**PROJECT:** DO MACRO UPGRADE  
**SITE NAME:** USWW MANITOU WATER  
**SITE CASCADE:** DN14XC247  
**ADDRESS:** 7225 WEST HIGHWAY 24  
 MANITOU SPRINGS, CO 80829  
 EL PASO COUNTY  
**LATITUDE:** 38.88689° N / 38° 53' 12.8" N  
**LONGITUDE:** 104.95846° W / 104° 57' 30.5" W  
**SITE TYPE:** MONOPOLE

SHEET TITLE  
**TITLE SHEET**

**SITE PLAN**

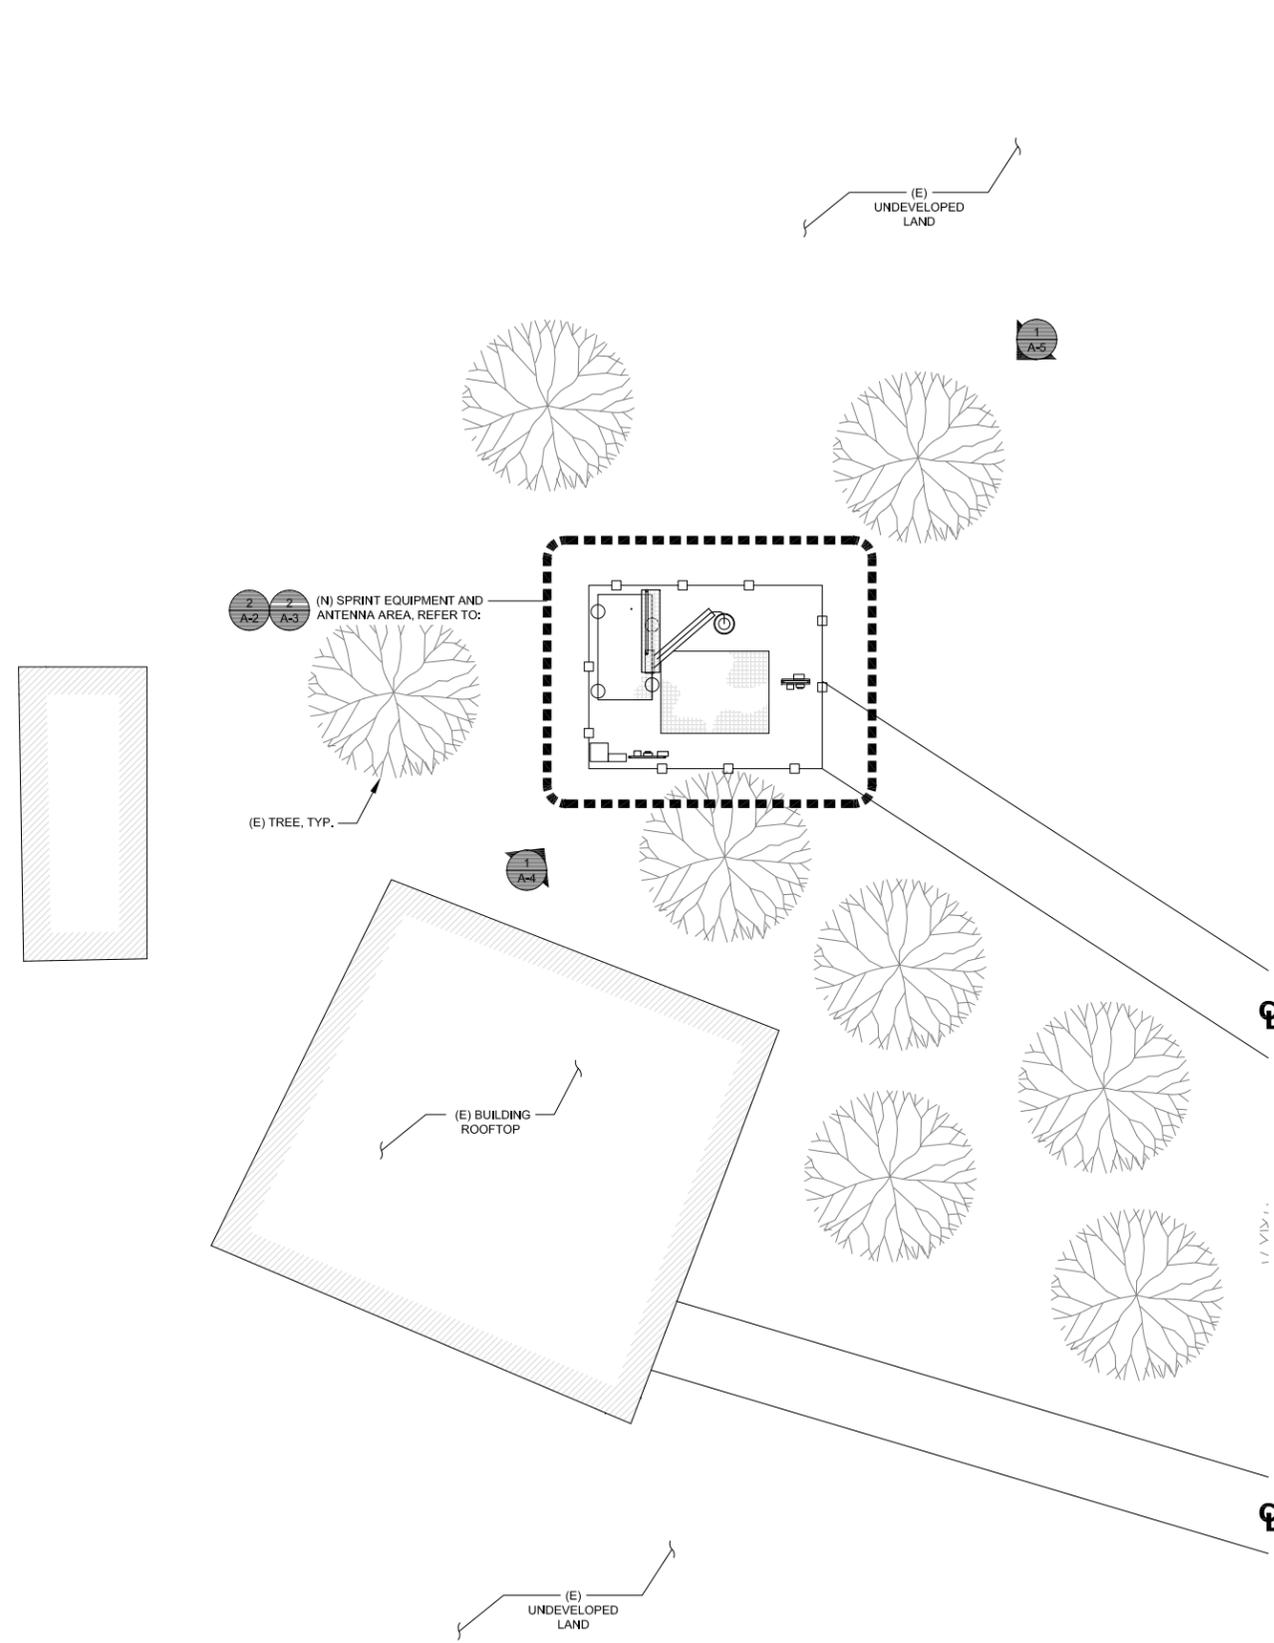
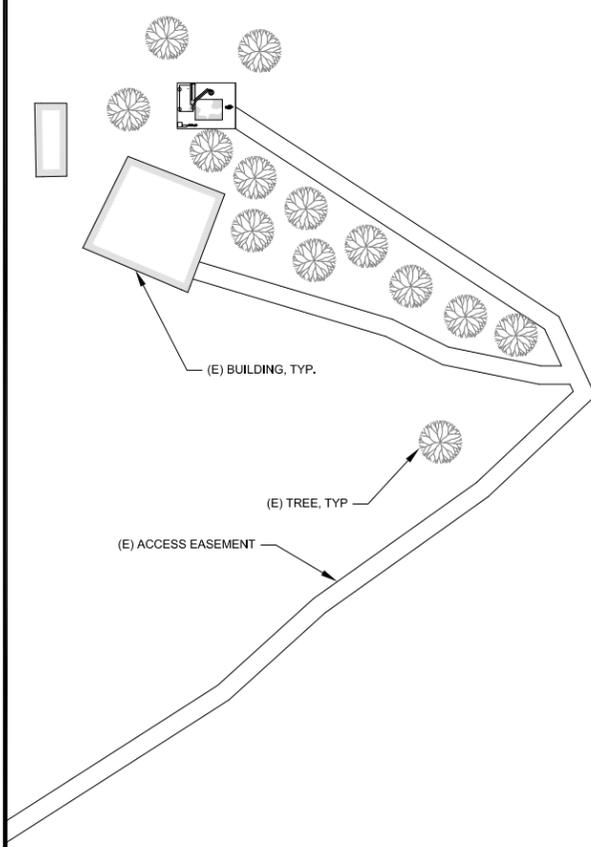
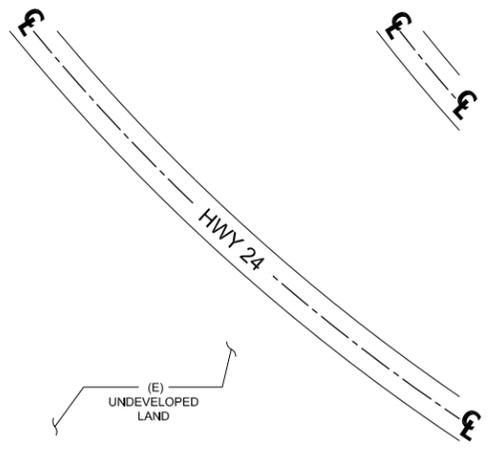
In the Site Plan Drawing spot upload a site plan showing the entire parcel, as well as the setbacks from the closest property line to the tower. Show all easements as well as driveways and structures.

In the Site Plan Drawing spot upload a site plan showing the entire parcel, as well as the setbacks from the closest property line to the tower. Show all easements as well as driveways and structures.

In the Site Plan Drawing spot upload a site plan showing the entire parcel, as well as the setbacks from the closest property line to the tower. Show all easements as well as driveways and structures.
